## **Bid Package 02 - Construction Bulletin 05**

**05/05/2020**

**Canadian County Expo Center  
3001 Jensen Road East  
El Reno, OK 73036**

# 1 ELECTRICAL VENDOR PLAN - EAST

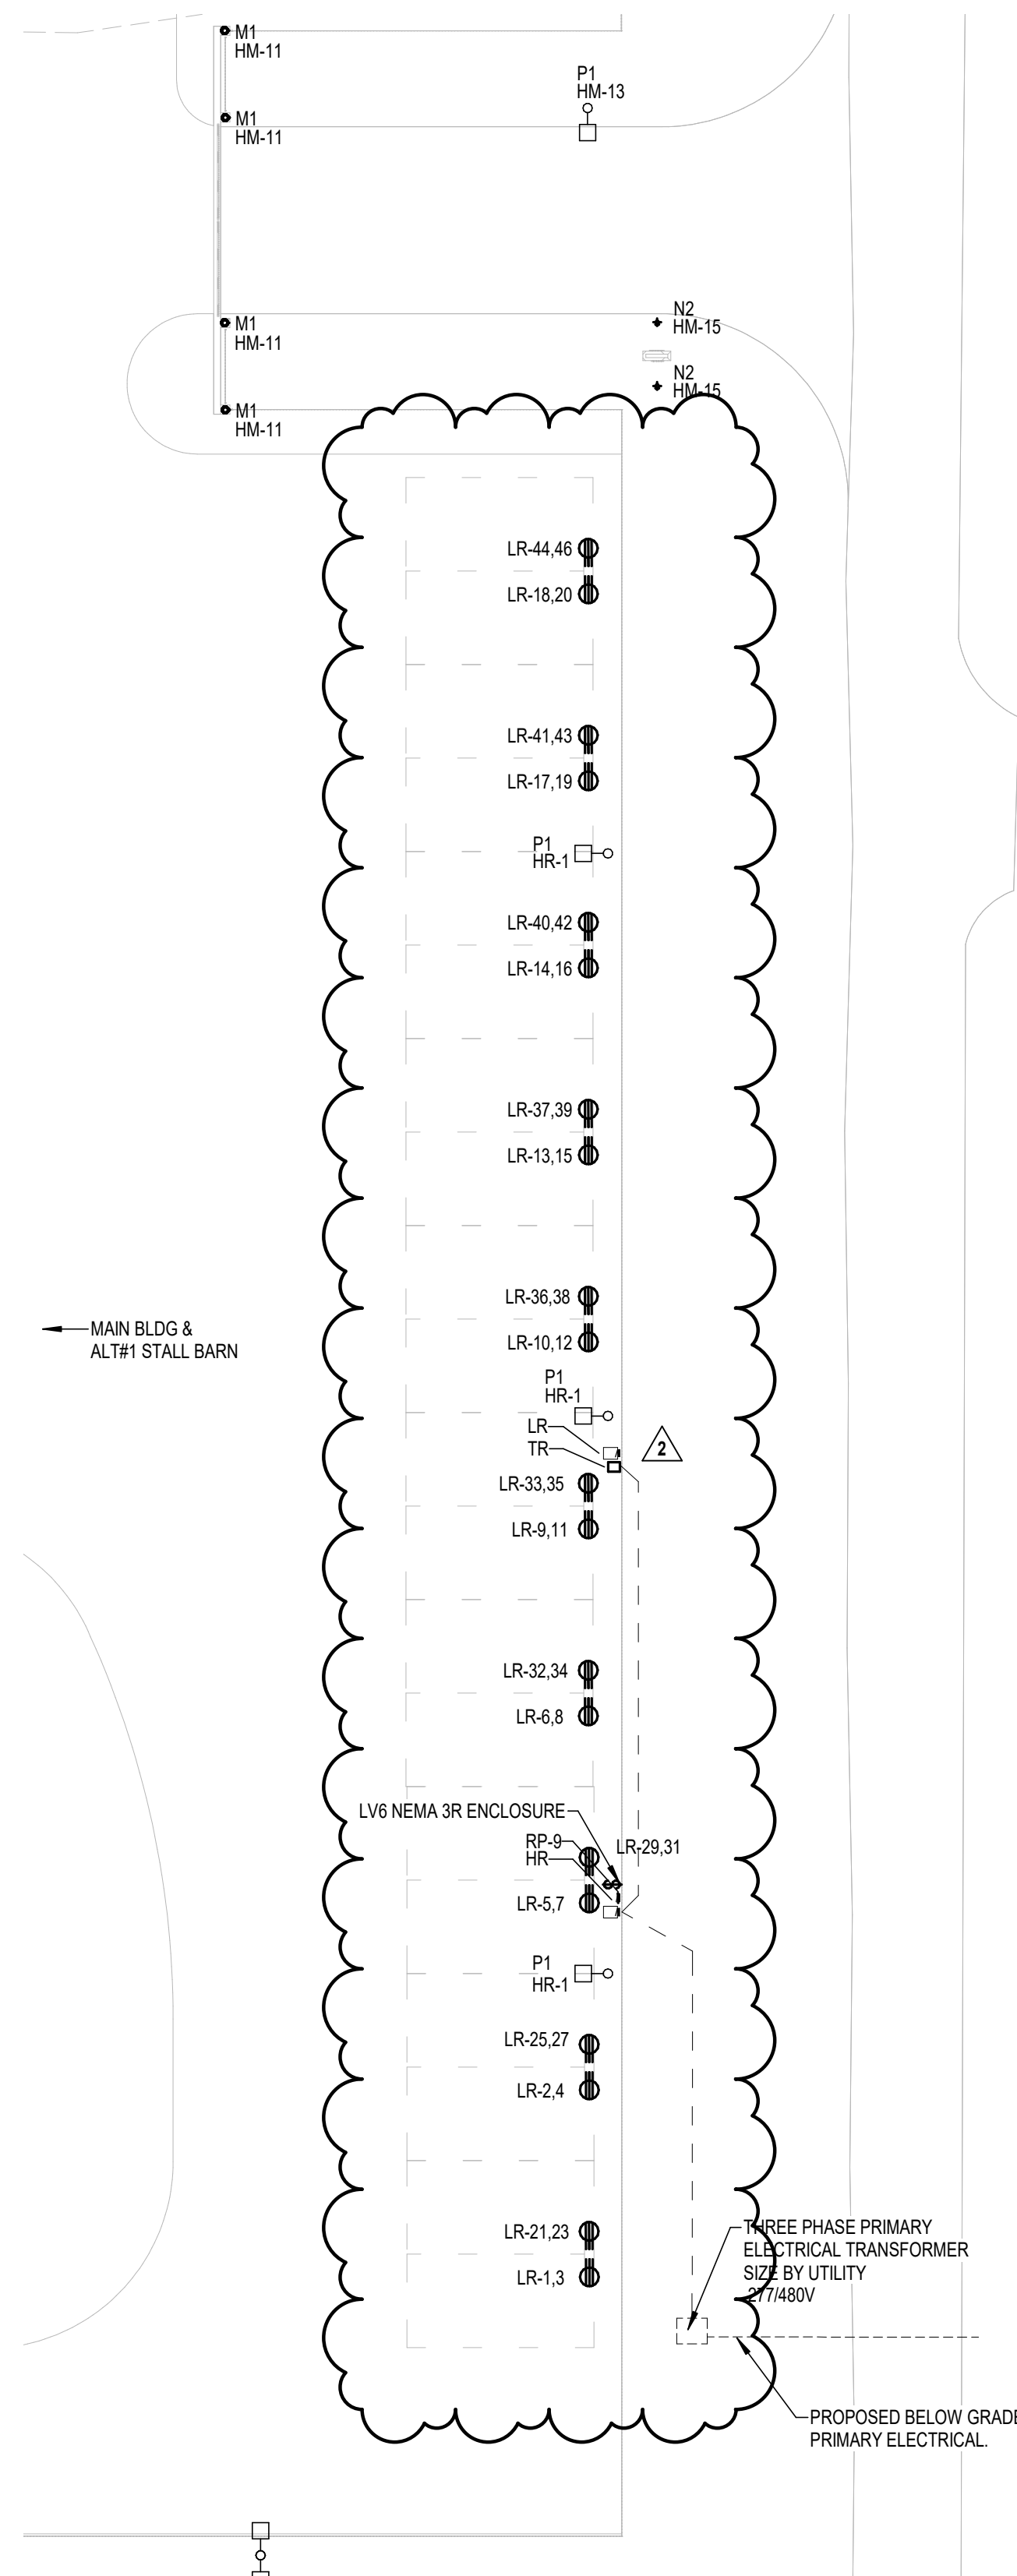
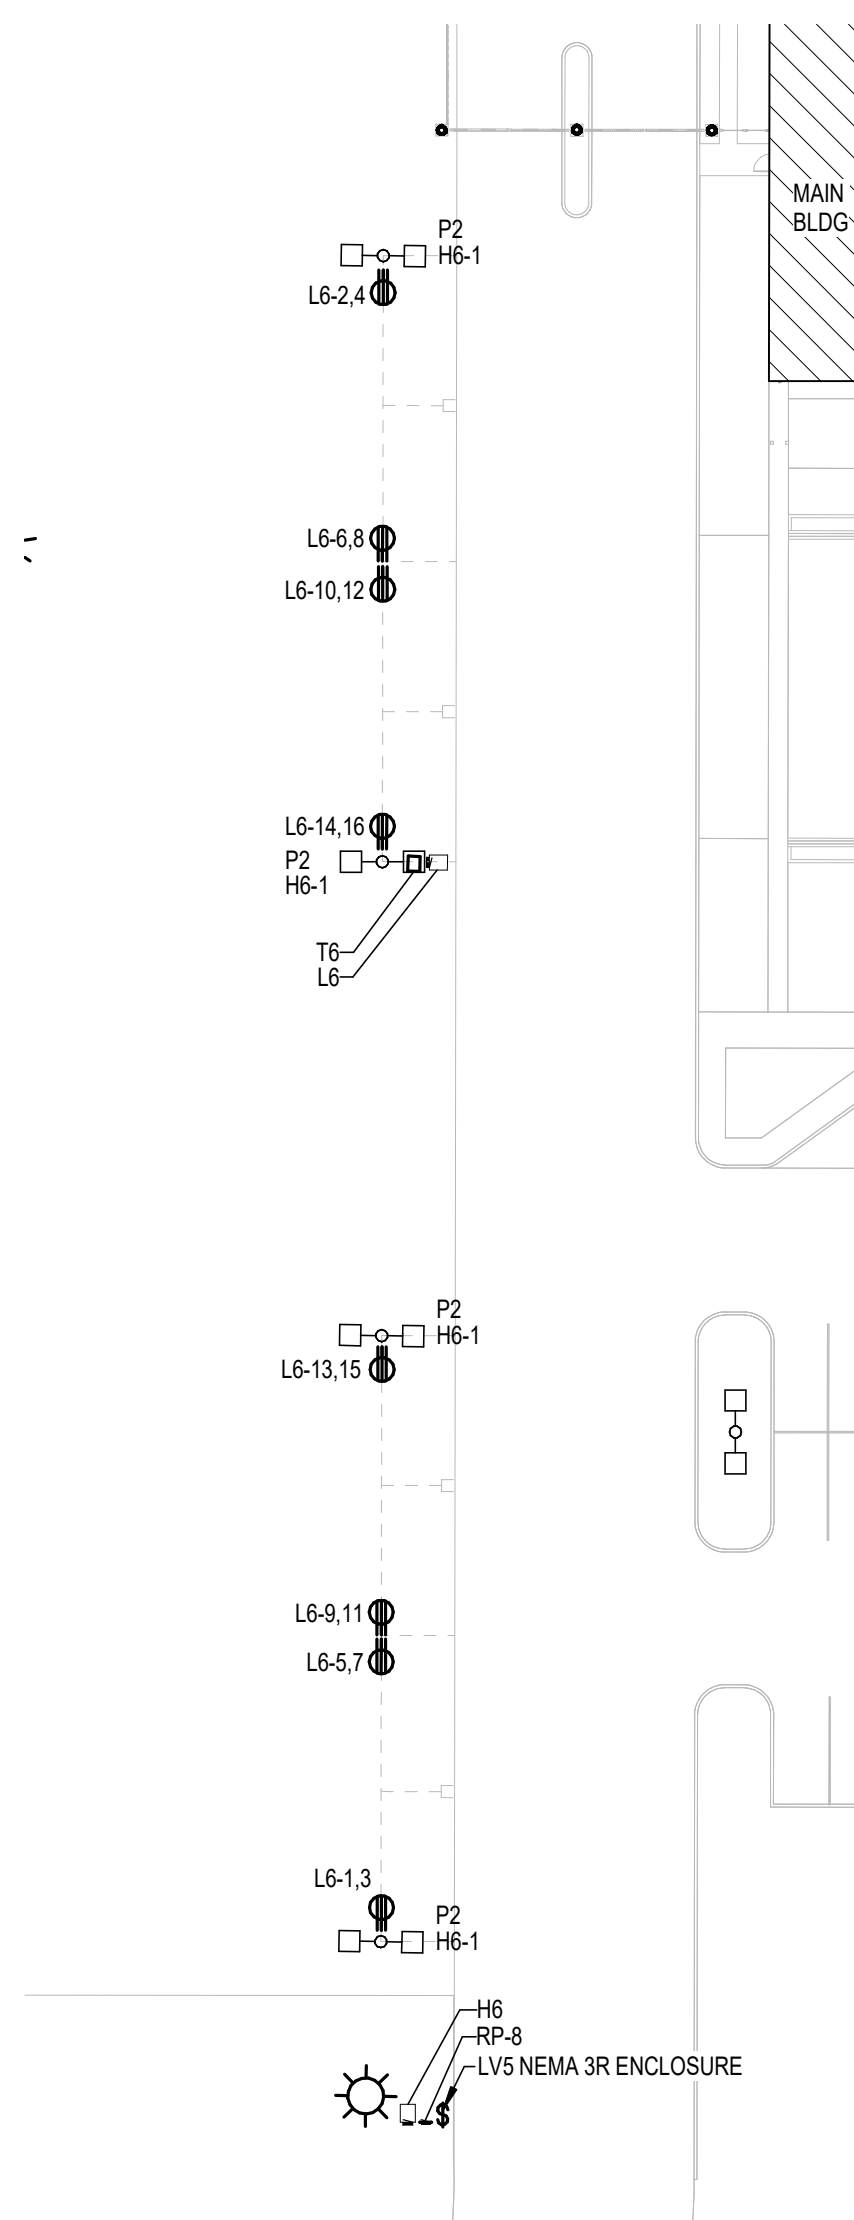
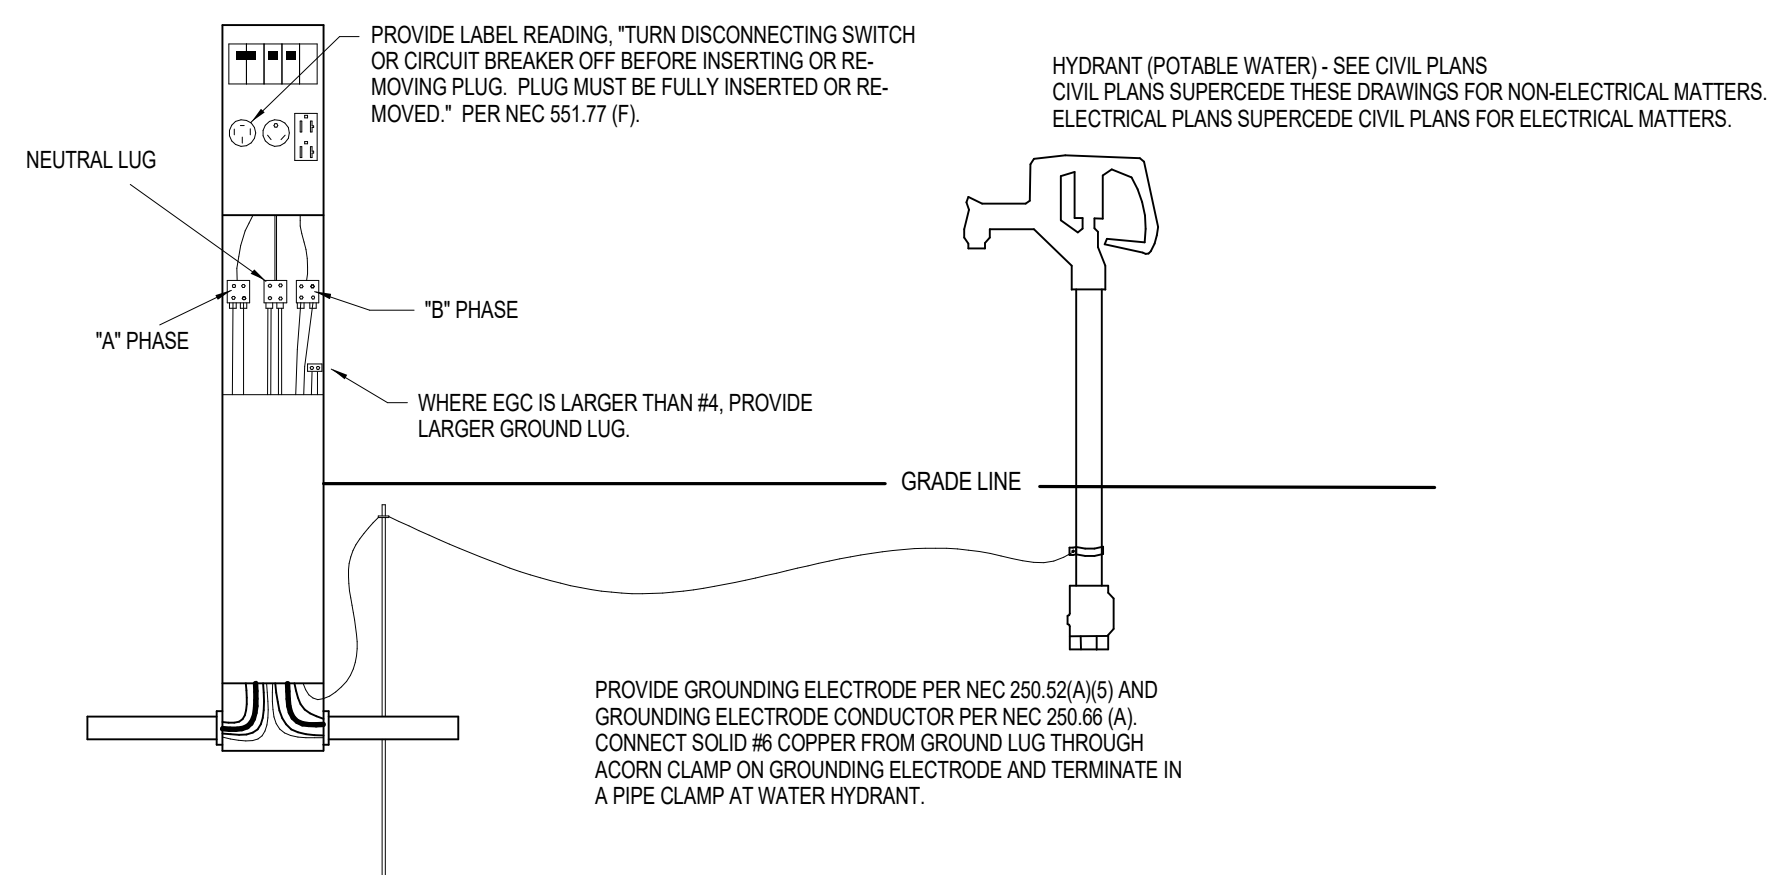
- a. Sheet E0-3 Electrical site enlarged area plan
  - a. Increased from 10 to 20 pedestals at East side of property.
- b. Sheet E2-0 Electrical power plan overall
  - a. included for completeness, no new specific information.
- c. Sheet E2-1A Electrical Power Plan - Area A

29. Clarification: In bid documents M1-1A, Vestibule 01.03.01 has a HP-3 shown that should be labeled MS-3.
30. Clarification: E0-3 detail (4) indicates 28 total power pedestals (8 & 20). Detail 1/E0-3 indicates only (10) locations. Each location shown should be a back-to-back set of pedestals to account for (20) total on east vendor area. (8) single pedestals are indicated on west vendor area and (8) singles are required.

- Sheet E0-3 Electrical site enlarged area plan
  - Increased from 10 to 20 pedestals at East side of property.
- Sheet E2-0 Electrical power plan overall

## 1 ELECTRICAL POWER PLAN - AREA A

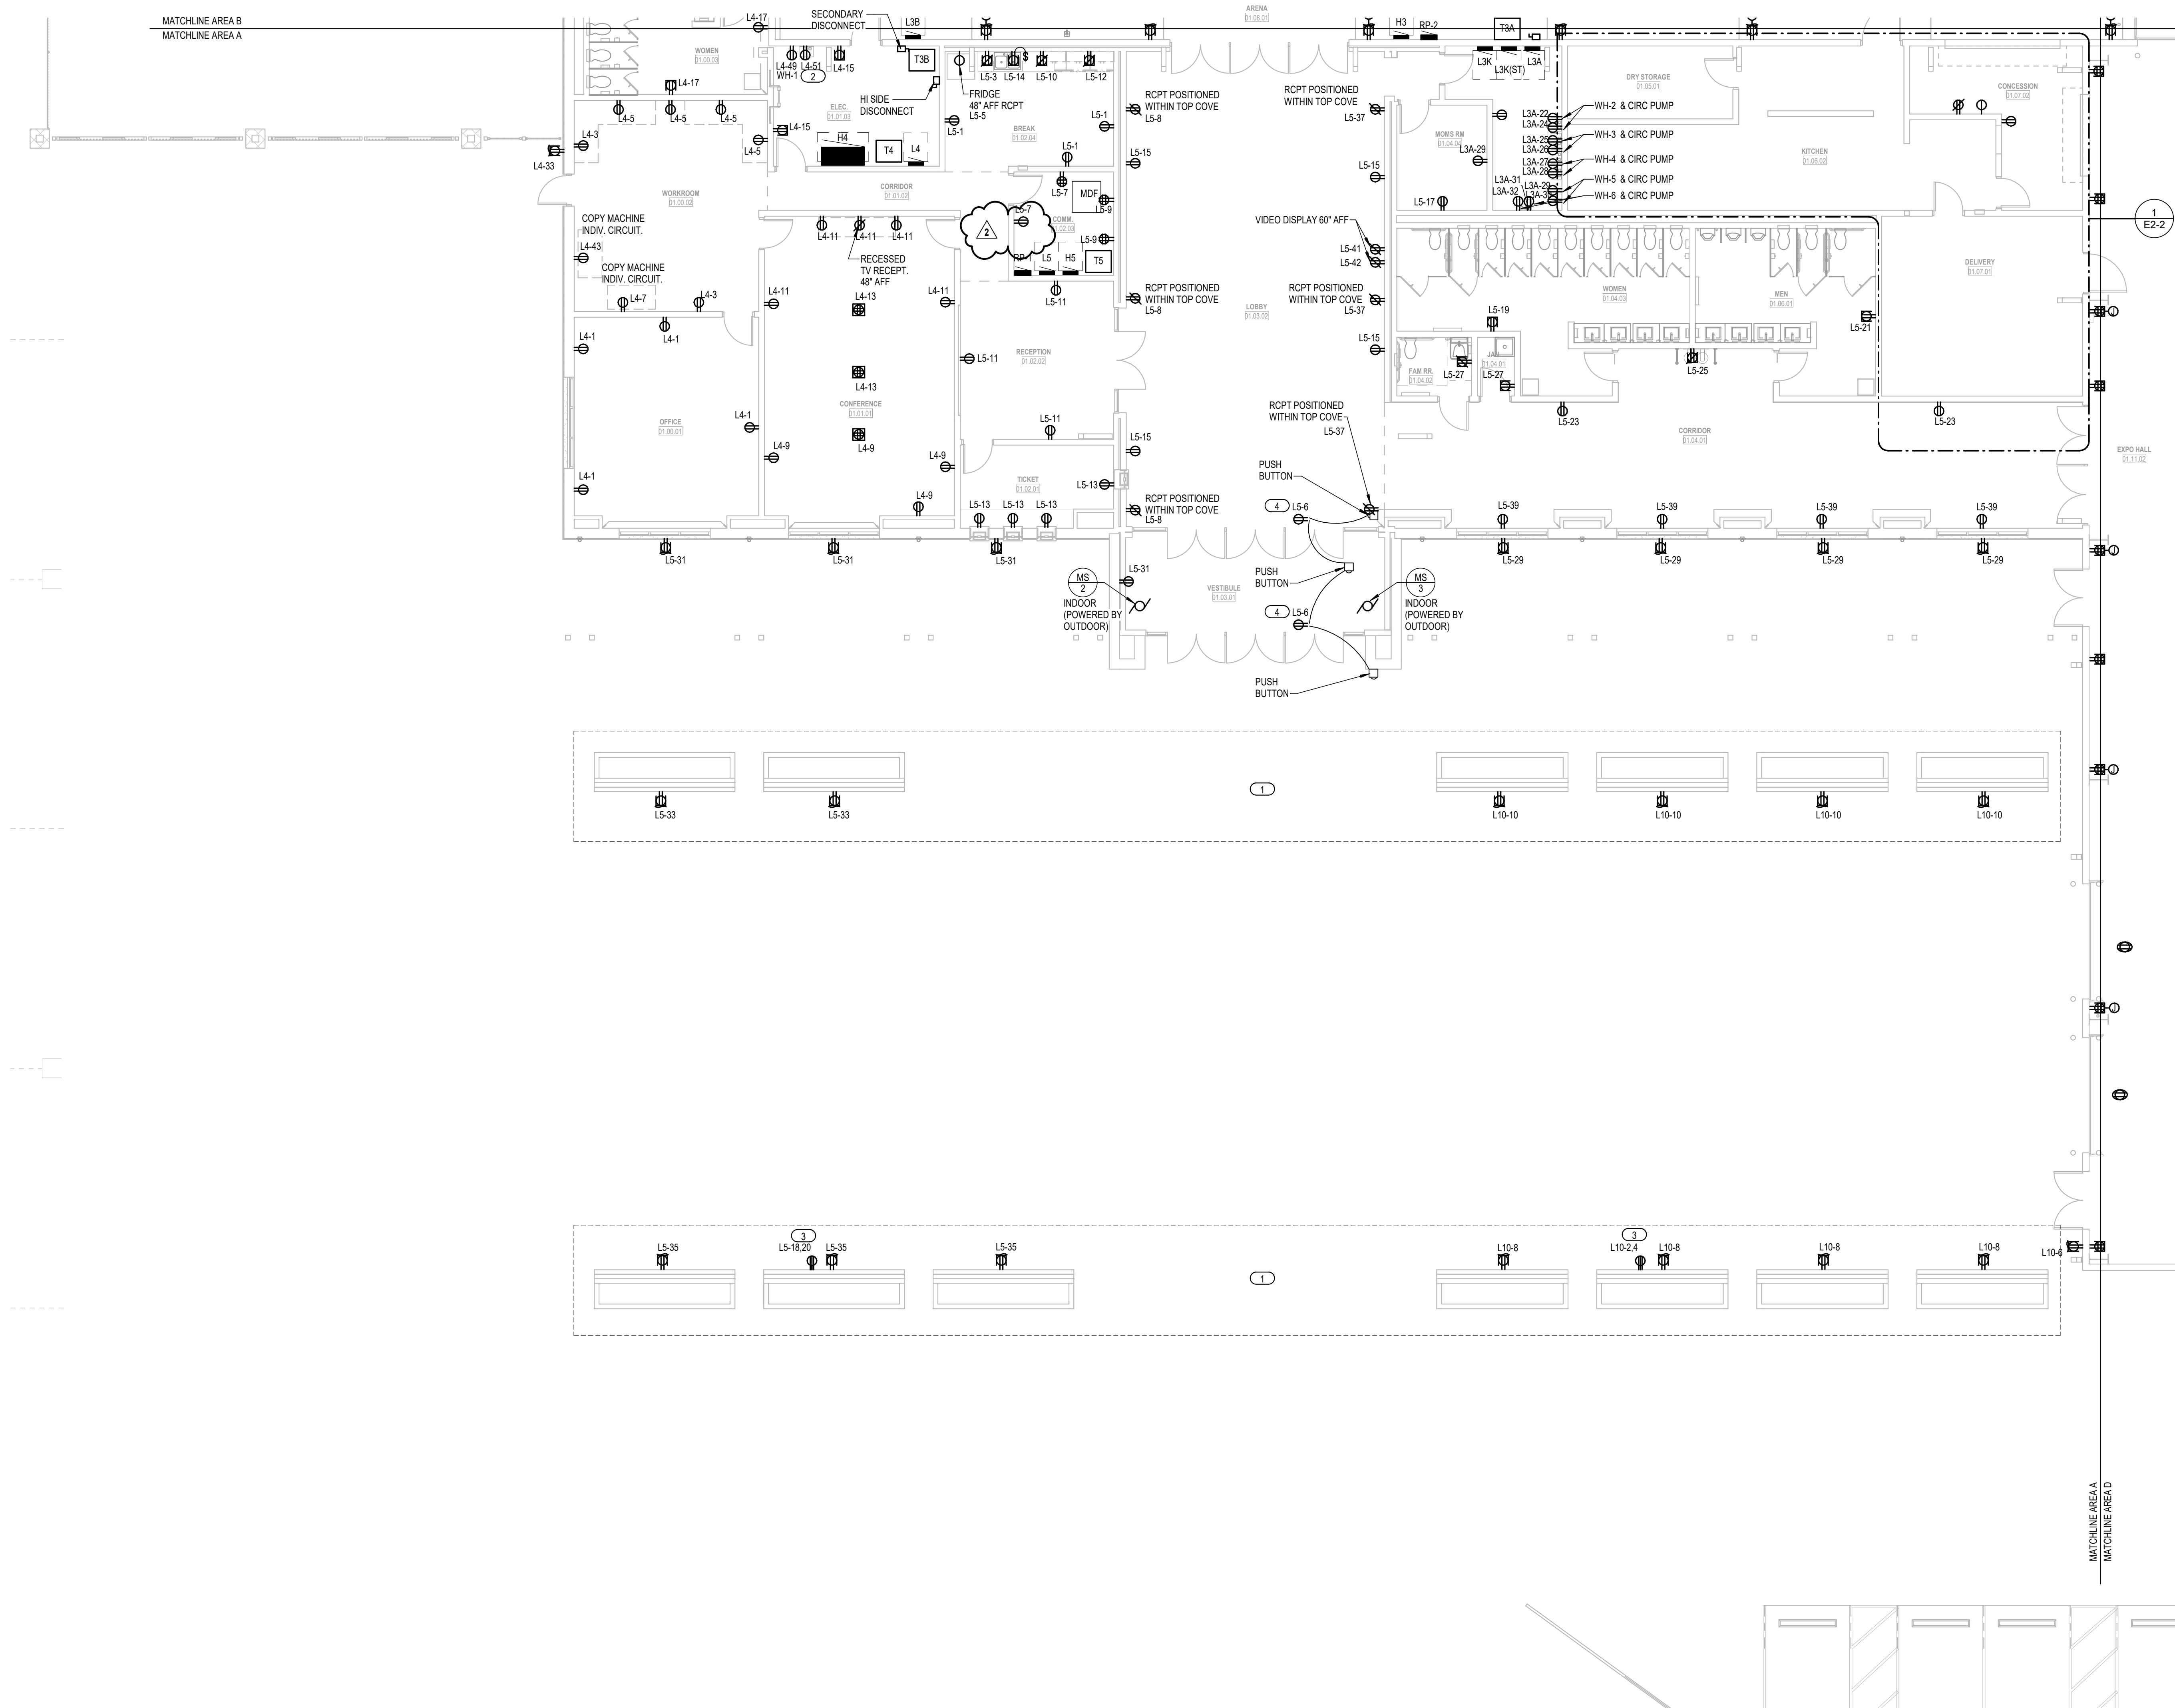
- a. Removed stray disconnect in room Comm 01.02.03.
- d. Sheet E2-1B Electrical Power Plan - Area B
  - a. Added ceiling mount receptacles for overhead doors.

- included for completeness, no new specific information.
- Sheet E2-1A Electrical Power Plan - Area A
  - Removed stray disconnect in room Comm 01.02.03.
